Paper for Consideration by ENCWG1

Isolated danger symbol in un-surveyed areas

Submitted by:	Hannu Peiponen / Furuno Finland
Executive Summary:	This paper request publishing of clarifications for discrepancy about content of the conditional symbology procedure UDWHAZxx found during review of S-64.
Related Documents:	N/A.
Related Projects:	Recently published new editions of S-52 and S-64

A part of screen plot as published in S-64 Ed 4.0.1

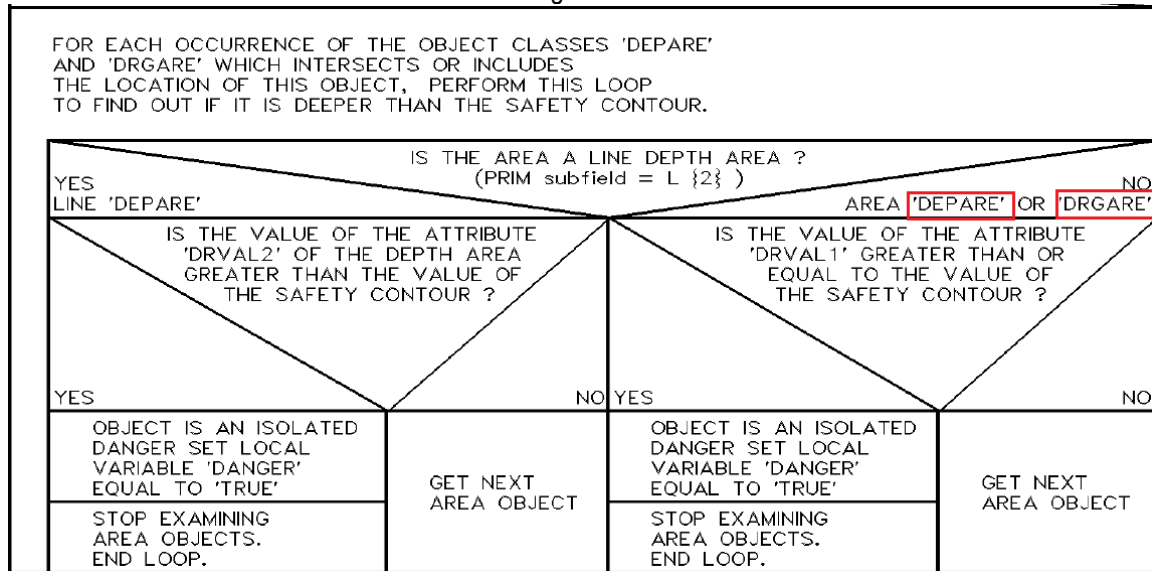
2. One part of the feedback was that the symbols in screen plots in S-64 chapter 5. Detection and Notification of Navigational Hazards had mistakes for those navigational hazards which were located in unsurveyed areas (UNSARE). Further it was found that for some manufacturers present in the ENCWG-TG1 meeting were of opinion that there were no mistakes and some manufacturers present in the ENCWG-TG1 meeting were of opinion that there were mistakes.

Note that those detected as navigational hazard are both presented as isolated danger (magenta cross) and highlight with yellow indication.

Same part of screen plot showing the presentation of the disputed objects if the object in UNSARE areas are newer isolated dangers.

Note that this plot do not have the planned route nor the highlight of navigational hazards.

See separate file 'CSP UDWHAZ04'

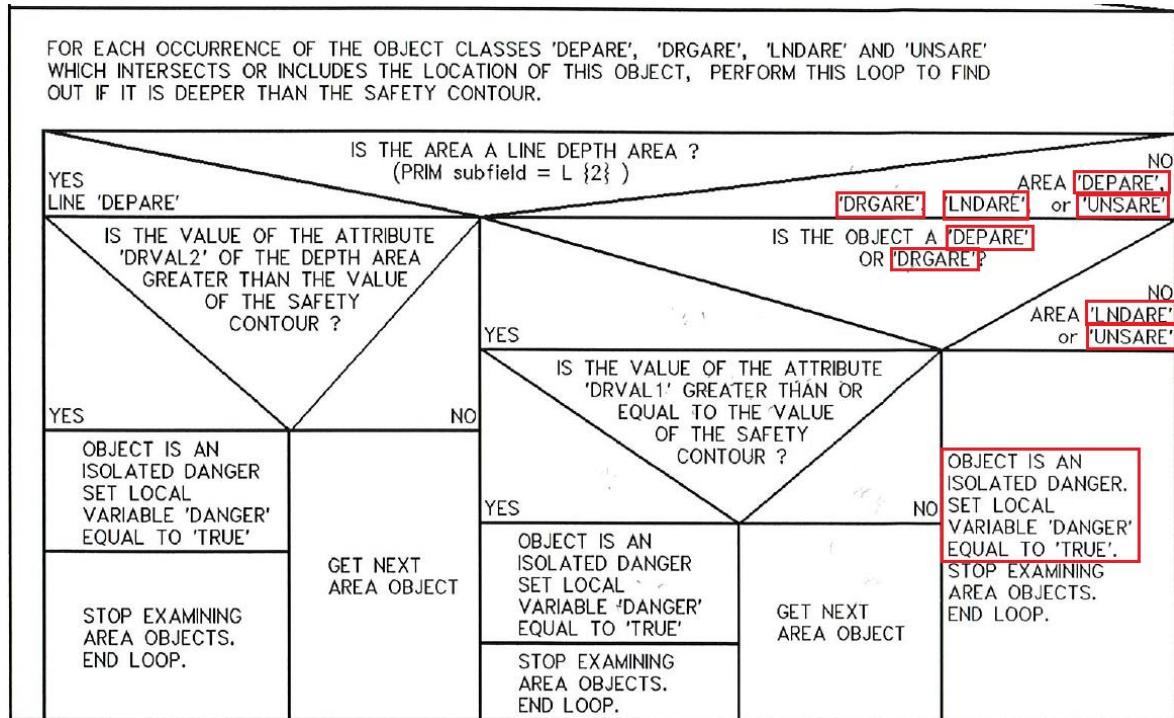
Clause 6.2.2 of the UOC has been in changed to include LNDARE in addition to the original DEPART or UNSARE as an underlay for area obstructions.

In order to determine whether an obstruction is an underwater hazard a revised CSP UDWHAZ04 has been written which examines LNDAREs and UNSAREs as well as DEPARTs and DRGAREs to determine whether the obstruction is an isolated danger lying in safe water.

Change CS(UDWHAZ03) to CS(UDWHAZ04) wherever it appears

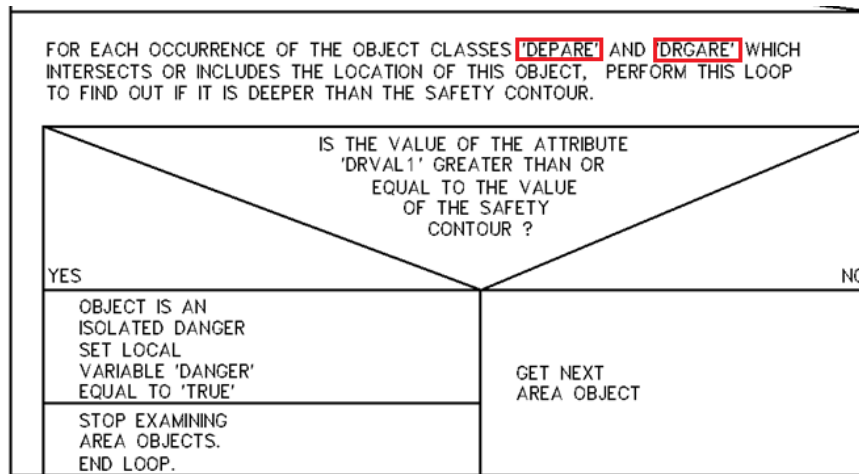
Revised CSP DEPART02 of Jan. '03 draws the safety contour from the edges of DEPART and DRGARE objects and highlights it as the safety contour. If, and only if, the safety contour is supported by a DEPCNT object, DEPART02 also labels it, as a mariner's option.

Edition 3.3 of the PresLib no longer recognises line depth areas. Revised CSP DEPCNT03 of Sept '02 merely draws and optionally labels all DEPCNT objects. (The higher display priority of the safety contour drawn by CSP DEPART02 will ensure that the safety contour overwrites the repeat of an ordinary contour drawn by CSP DEPCNT03.)

In particular, because edition 3.3 of the PresLib no longer recognises line depth areas, add to PresLib section 11.2 line look-up table the following 'no symbol' entry: "DEPARE", "", "", "", "S", "", ""
